Determination of a Final Occupation Certificate Application

Final Occupation Certificate No: 2009/3215

Address: 22 Chiltern Road, Ingleside

DRAWING REFERENCE NO S02, S03, S11, S14

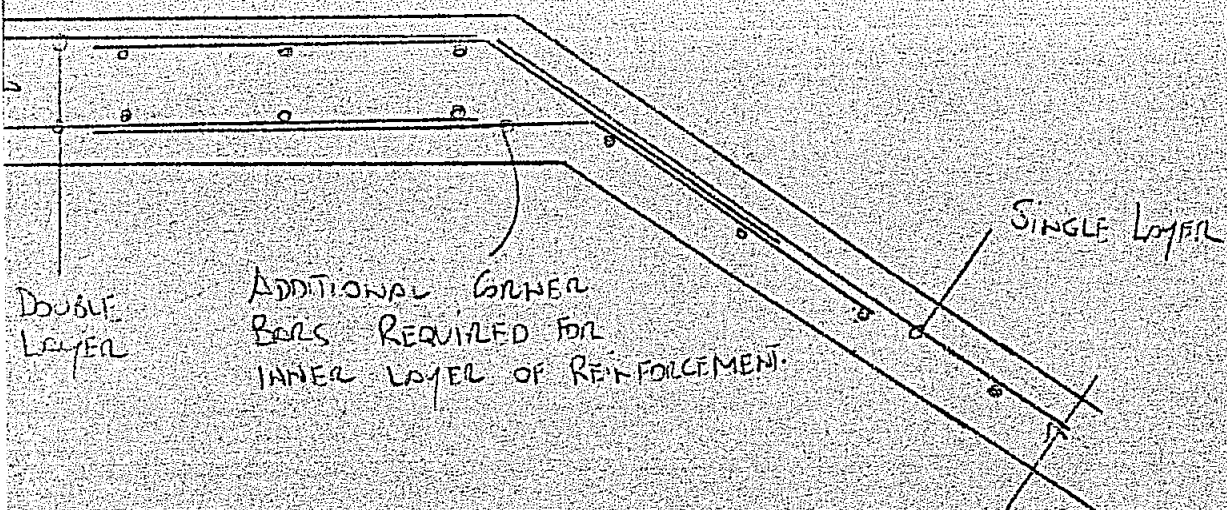
Pool corner reinforcement needs to be rectified as follows.

DRAWING REFERENCE NO S01 - S03.

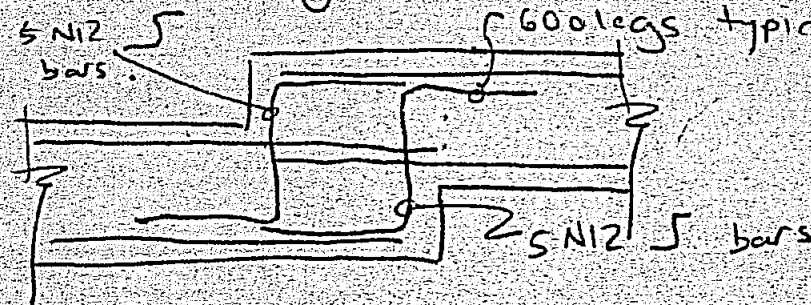
FOOTING PREPARATION HAS BEEN INSPECTED. BUILDOR TO ADDRESS THE FOLLOWING:

- i) At step in footing, provide "Z" lap bars as per:

PROJECT ADDRESS 22 Chilton Rd Inglewood
JOB NO 1226 DATE 24.6.09 INSPECTION TIME 10:00AM WEATHER overcast / WET
INSPECTION REQUESTED BY NICK GAFFNEY - MOULDS
OTHERS PRESENT _____
INSPECTION CARRIED OUT BY BEN SIMPSON
ELEMENTS INSPECTED FRONT TERRACE FOOTINGS
DRAWING REFERENCE NO SG1-SC3

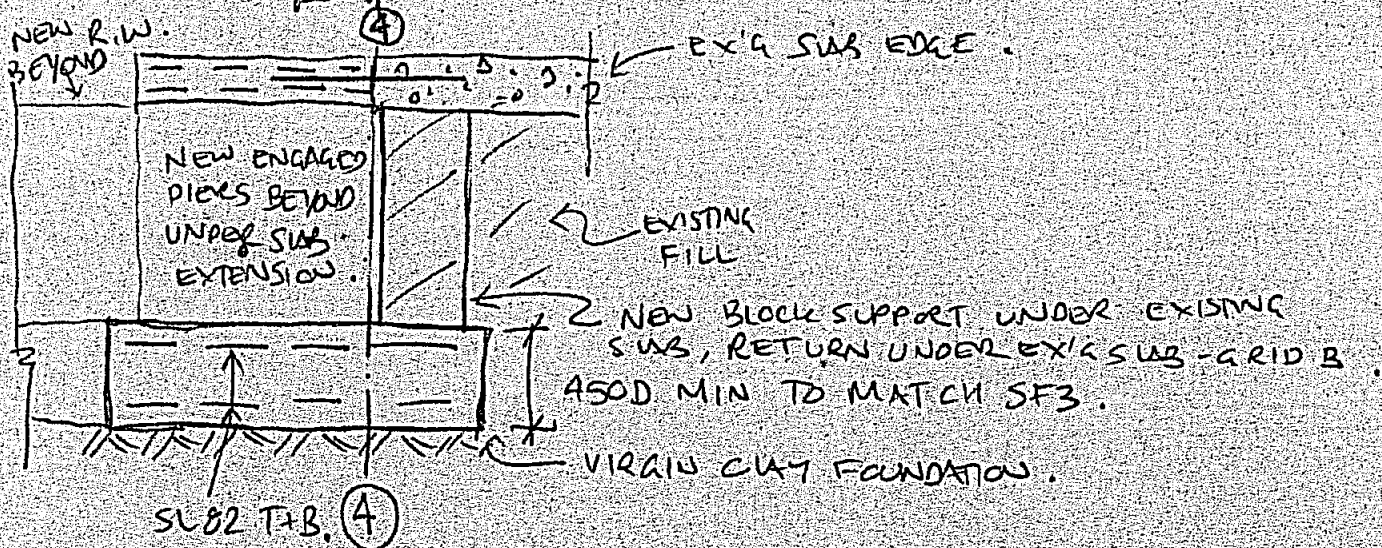
1v) ALONG GRID 4, between grids A & B, clean out existing fill, a minimum of 300 mm under existing slab & pour mass concrete pad footing to support underpinning walls as per:
